Project Name: Hearthstone Place Apartments

Project Number #: 21-2674

☒ Detail Design Review

Date: June 24, 2021

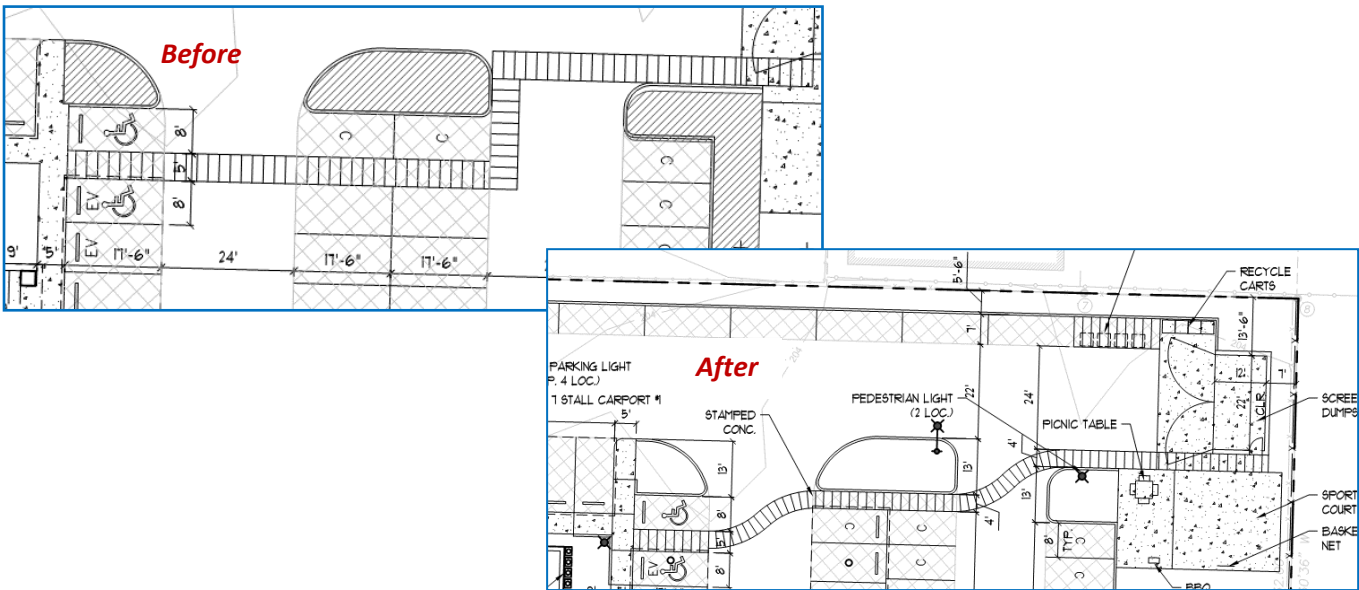
The pedestrian connection from the sidewalk through the east parking lot to the sports court is not entirely defined at this time other than with striping on the site plan. The pathway appears precarious as it extends from the sidewalk between two accessible vehicle spaces, between two additional vehicle spaces (compact and standard size spaces) and behind a vehicle parking space to the solid waste area.

The Board should consider whether the pathway is safe the way it is laid out, or if it needs to be realigned in a way that provides more comfort and safety for residents. One option would be to show a surface material for the walkway that physically and visually defines the walkway as pedestrian space – not just paint on asphalt – rather a change in material such as concrete or raised walkway. Staff looks to the Board to discuss options for improving pedestrian access from the east end of the building across the parking lot to the sports court.

- Provide an alternative path and/or surface material associated with the pedestrian walkway to the sports court, not just paint.

Detail Design Review: The pedestrian pathway from the sidewalk through the rows of parking has been re-routed through the parking lot and revised to include raised and stamped concrete treatment. See the Site Plan, Sheet SP1.0 (above), the Landscape Plan, Sheet L1.0, and sheet 7 for more details (materials and colors).

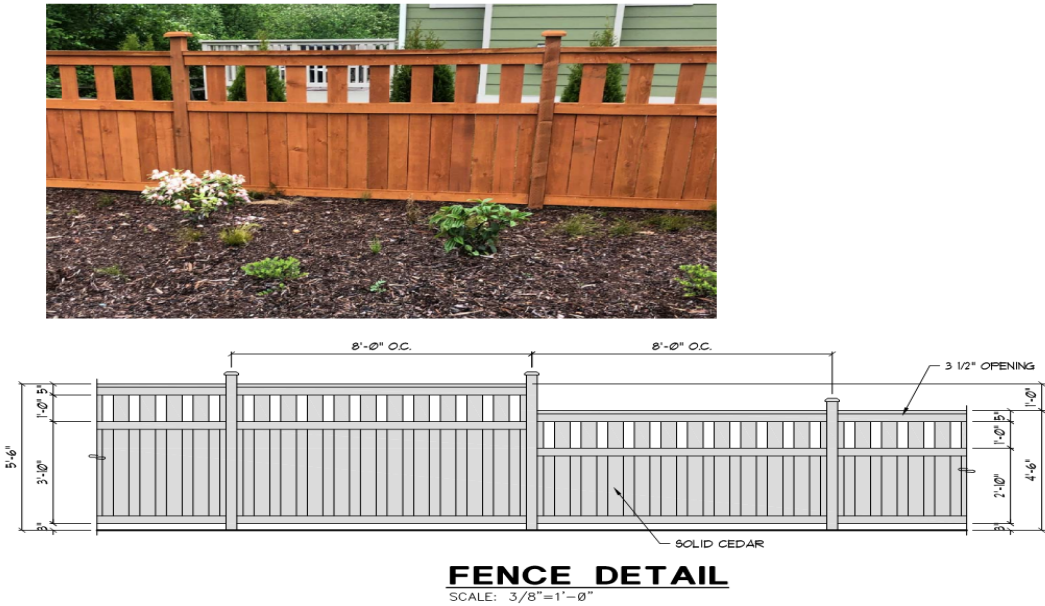
Staff Response: Fencing is proposed around three sides of the development: north, east and south. The site plan and landscape plan indicate an *existing* 6’ solid fence, and a *new* fence with a slightly different design with solid railing atop and caps on the top of posts – the second being a more attractive design than the solid cedar fence (Sheet SP1.1). If fencing around the perimeter is the choice for site design, a single type of fencing should be installed consistently around the site. Landscaping will be provided immediately adjacent to the fencing around the property, which will provide an attractive distraction from the solid line of fencing.

- Install a single style of fencing around the development site.

Detail Design Review: The type of fencing chosen to surround three sides of the development is proposed to be semi-solid cedar privacy fencing shown on Sheet Sp1.1. The fencing will vary in height along the perimeter.

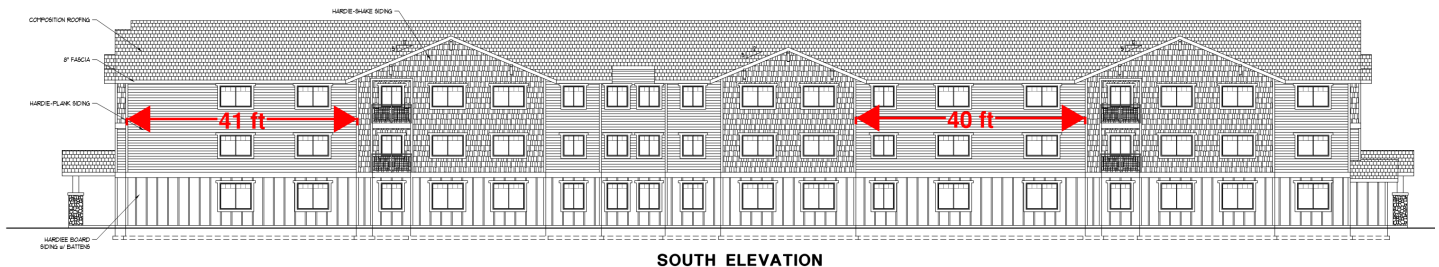
Staff Response: The building footprint is approximately 60’W x 240’L. The ins and outs of the building modulation should ‘read’ similarly around the building envelope. The east and west facades exhibit similar style and features – covered gable entry, stone columns and similar wall articulation (except for the addition

of the electric storage closet at the east façade). The north and south facades differ, not insofar as materials, roof form or fenestration, but in modulation and articulation. Up and down and side to side, the facades should read the same.

Staff looks to the Board to facilitate a discussion with the applicant about developing an architectural concept that results in a unified and functional design - one that fits well and supports the site and surrounding built environment. See also OMC 18.170.110.

- Arrange the mass of the building such that secondary architectural elements like modulation and articulation, and features such as decks and overhangs, combine to produce a common ‘legibility’, or single form and architectural style.

Not mentioned at the concept design review Board meeting, although required, is that there are expanses of wall sections along the south building wall that are over 30’ in width. In these areas the wall plane is flat. Building modulation helps break up flat planes, gives buildings depth, dimension and separation, as in fenestration, and adds interest to the building. Options for breaking the expanse of these wall sections might include decks, balconies, window bays, sunshades, porches, building bump-outs, or other forms expressed in the front façade.

- Building modulation shall be provided at intervals of no less than 30’ around the building envelope.

Detail Design Review: Secondary building design features have been re-designed, and the building now reads as common legible rhythm and a pattern in the building design that did not exist at the concept stage of review.

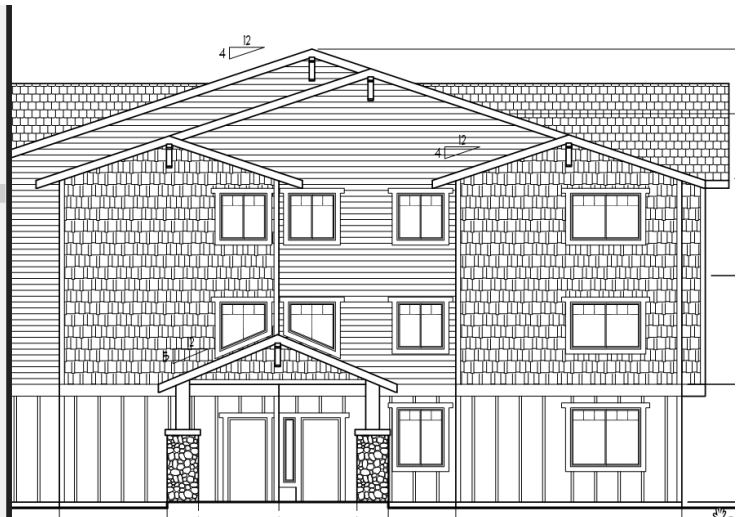
The windows should not exist in the same plane as the building wall – they should not be flat but rather recessed or extending beyond the plane of the wall. Options that would provide dimension and distinguish the windows include framework around the openings in the form of sash, sills or trim that extend from the façade (or recessed). See also OMC 18.170.110.

- The windows shall exhibit depth in the form of window elements that recede or protrude from the building wall.
- Provide details of the windows in the detail design architectural packet – type(s), design and photos.

Detail Design Review: Window details don't appear to be provided in the architectural plan set. However, Sheet 7 does note 'white vinyl jeld-wen windows', and the elevations and perspectives suggest that the window frames project from the wall plane somewhat. Windows that are flat with the plane of the wall detract from the quality of building design and overall impression of the development.

- Windows shall be recessed or protruding to create shadows and depth to the wall plane.
